[Docket No. 97-SW-35-AD; Amendment 39-10521; AD 97-20-09]

**Airworthiness Directives; Bell Helicopter Textron (Bell)-manufactured Model HH-1K, TH-1F, TH-1L, UH-1A, UH-1B, UH-1E, UH-1F, UH-1H, UH-1L, and UH-1P Helicopters; and Southwest Florida Aviation SW204, SW204HP, SW205, and SW205A-1 Helicopters**

**ACTION:** Final rule; request for comments.

Figure 1

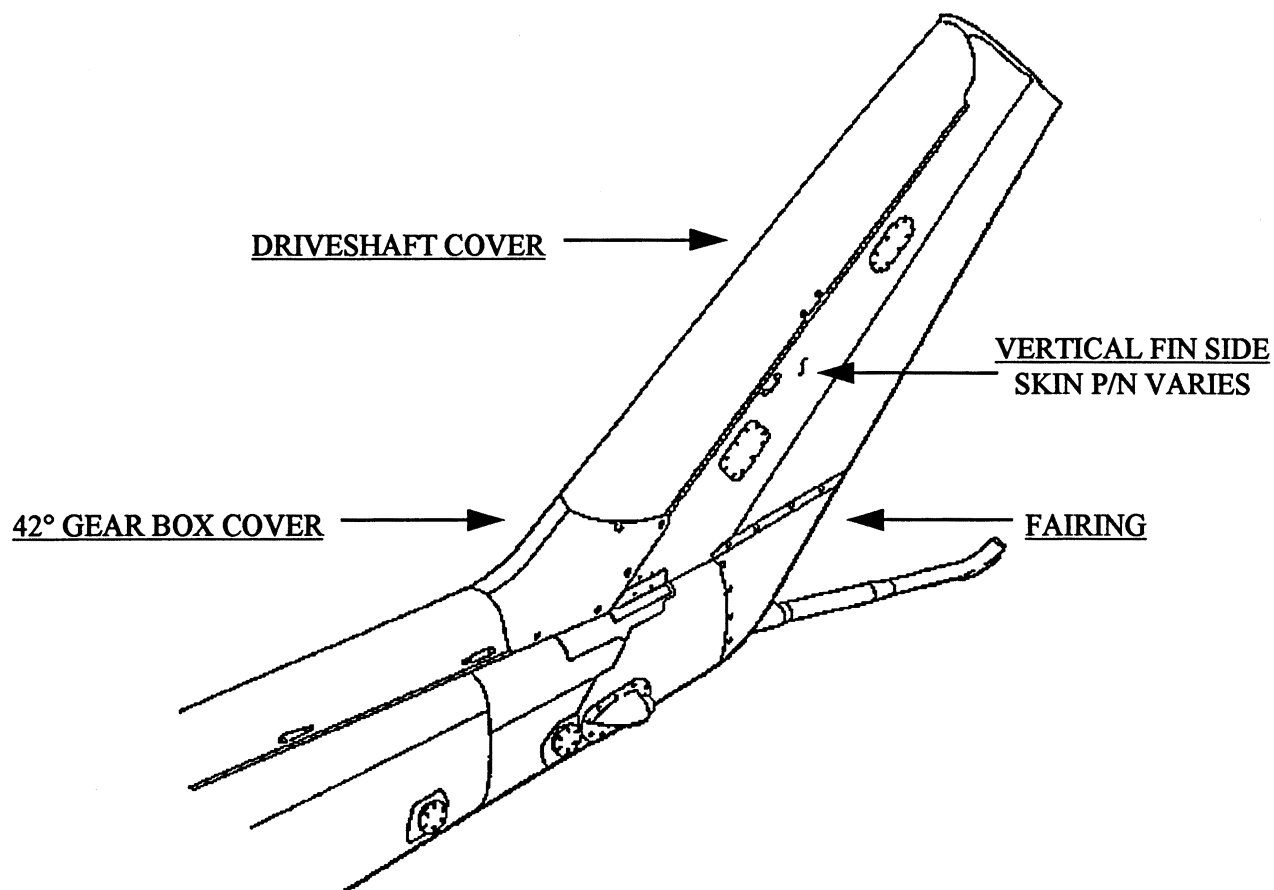
(1) Remove the 42° gearbox cover and open the drive shaft cover on the vertical fin spar assembly (see Figure 1).

(2) Remove the 42° gearbox cover and open the drive shaft cover on the vertical fin (see Figure 1).

Detail - A-  
Figure 2

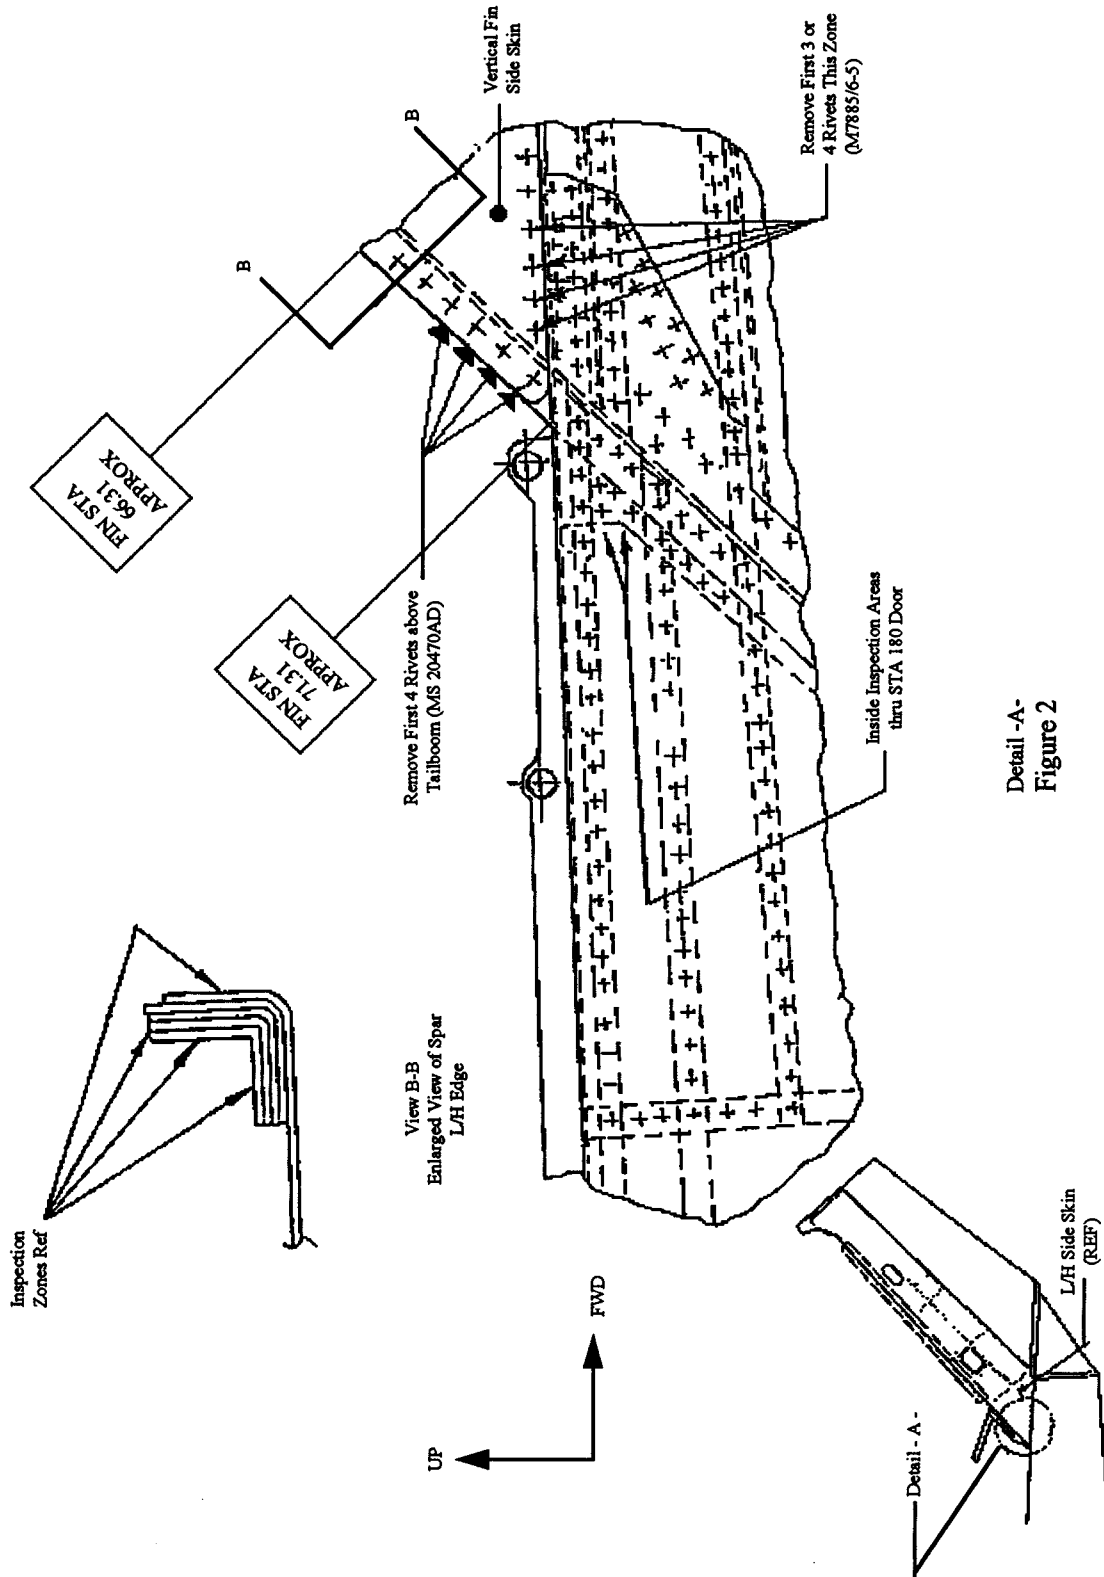
(2) Remove the first four rivets from the vertical fin spar located at the bottom of the vertical fin spar left-hand side at the tailboom and vertical fin spar junction, and the first four rivets aft of the junction along the lower

edge of the vertical fin spar side-skin as shown (see Figure 2).

(6) Reinstall the vertical fin spar skin lower edge rivets using M 7885/6-5 rivets (see Figure 2).

(3) Through the lower aft tailboom inspection door, using a bright light and an inspection mirror, inspect the vertical fin spar assembly adjacent to the tailboom top skin on the forward side, paying special attention to the left-hand edge and the adjacent surfaces (see Figure 2).

(4) In a ventilated work area, clean all surfaces to be inspected with a cloth dampened with aliphatic naphtha or an equivalent cleaning solvent. Using a bright light and a 10x magnifying glass, inspect the vertical fin spar assembly adjacent to the tailboom top-skin on the in-board and out-board sides, the vertical edge, and the two open rivet holes. Using a bright light and a mirror, inspect the aft side of the vertical fin spar in the same area. Special attention must be given to the left-hand edge of the vertical fin spar and any adjacent surfaces between fin stations 66.31 and 71.31 (see Figure 2).

Figure 3  
View Looking Inboard  
Left Side

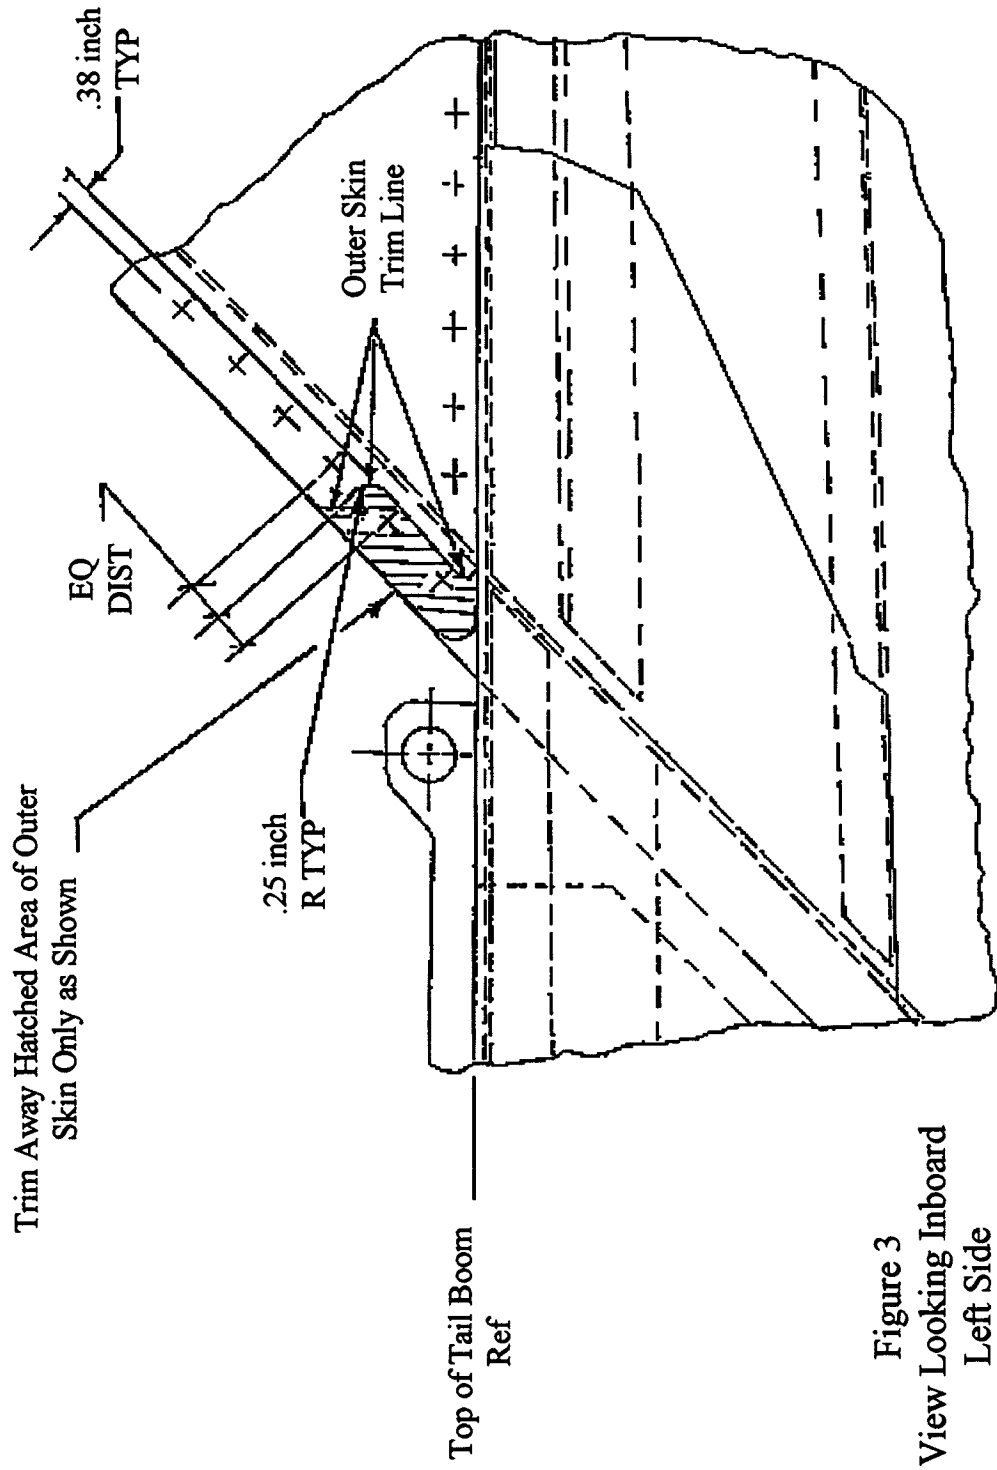
(3) Trim the vertical fin spar left-hand skin using extreme care to not damage the vertical fin spar assembly (see Figure 3).

Figure 4

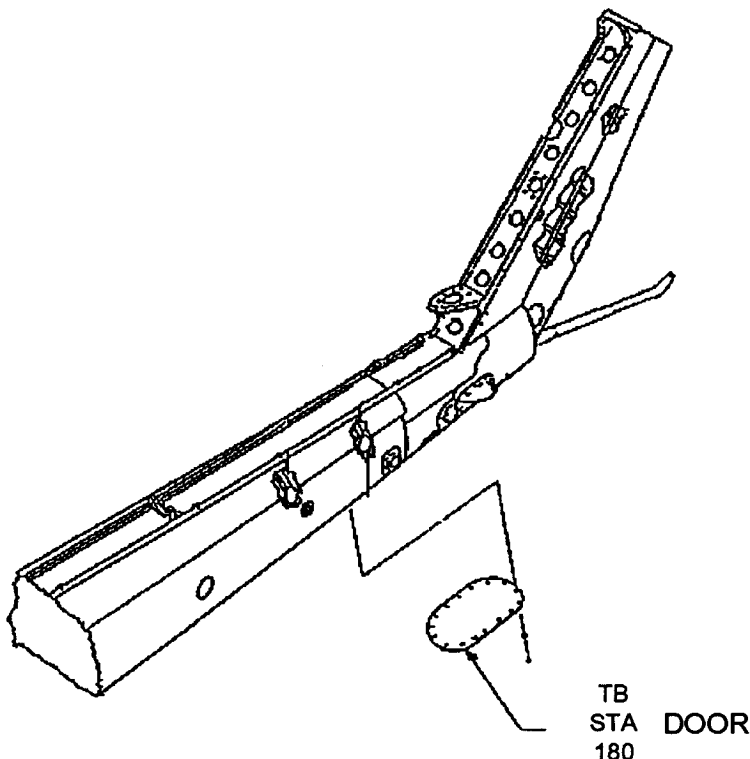
(1) Remove the lower aft tailboom inspection door, located at tailboom station 180 (see Figure 4).
